**Type of Action:** Plug and Abandonment

**HILCORP ENERGY COMPANY**  
**CANYON LARGO UNIT 174**  
**P&A NOI**

AFMSS 2 Sundry ID 2776641

Operator: Hilcorp Energy Company  
Well: Canyon Largo Unit 174 (API#30-039-20537)

**CANYON LARGO UNIT 174 - PROPOSED WELLBORE SCHEMATIC**

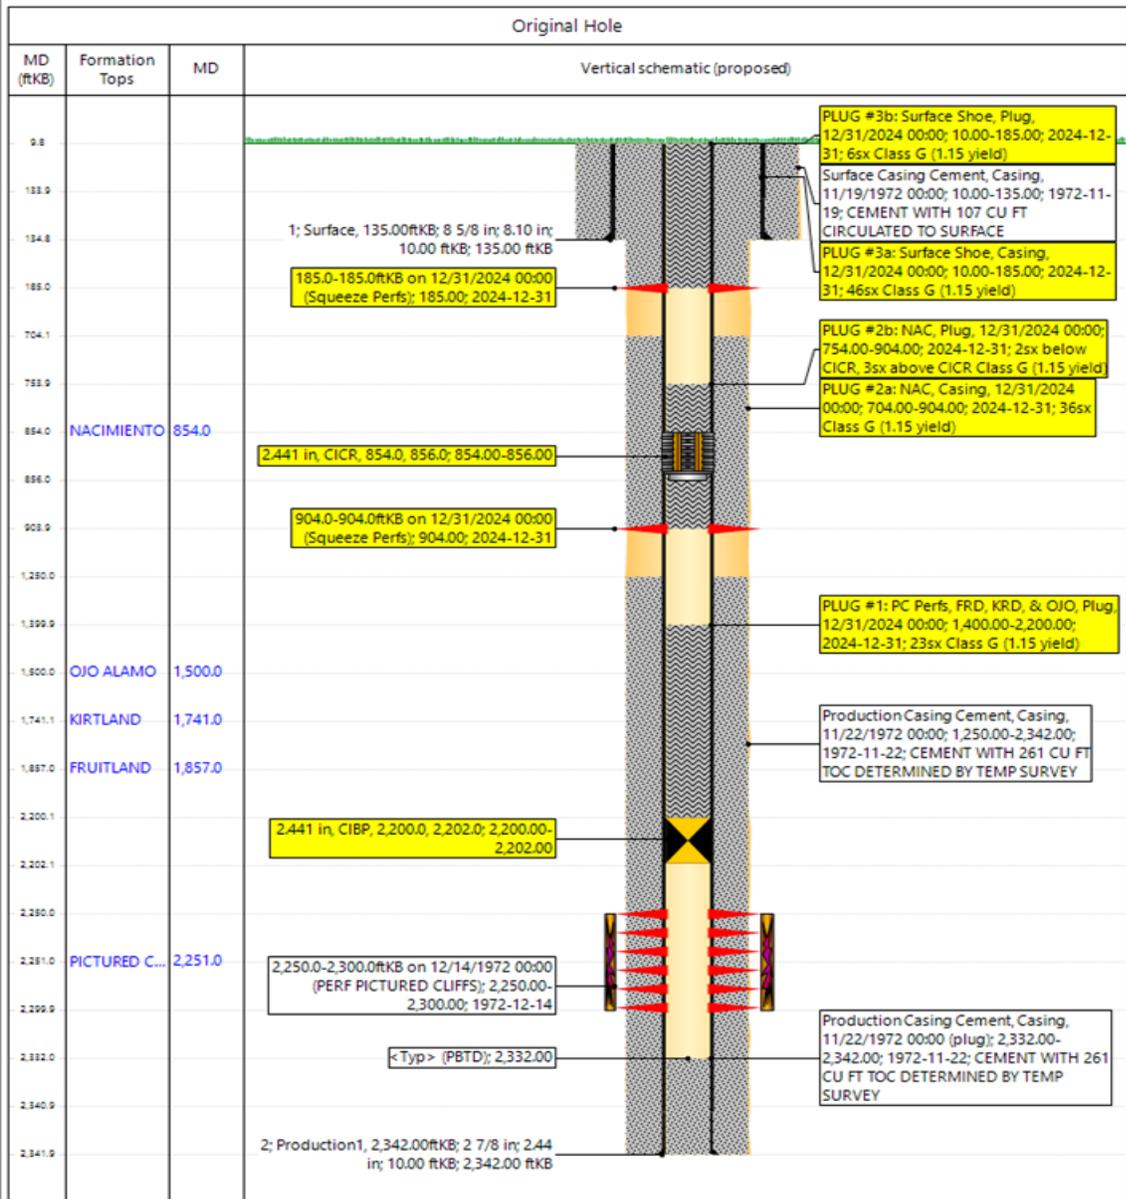
-Vertical wellbore, all formation depths are TVD from KB at the wellhead.  
 -Adjust the top of Plug 1 to 1260' to account for the BLM geologist's Ojo Alamo top.  
 -Place the CICR for Plug 2 at 430', with the squeeze holes at 480' and adjust the TOC appropriately to account for the BLM geologist's Nacimiento top.

- a. Adjust Plug #1 to cover BLM Ojo Alamo formation top pick @ 1360'. Cement should be brought to a minimum of 50' above Ojo Alamo formation top (1310' – 2200').

- b. Adjust Plug #2 to cover BLM Nacimiento formation top pick @ 430'. Perforate @ 480', CICR set @ 430', and cement brought to minimum 380'.
3. **NOTIFICATION:** Farmington Office is to be notified at least 24 hours before the plugging operations commence at (505) 564-7750.

Created By	Condition	Condition Date
mkuehling	Adjust plug 2 NMOCD pick for Nacimiento is 430 - Notify NMOCD 24 hours prior to moving on - Monitor string pressures daily report findings on subsequent	3/14/2024
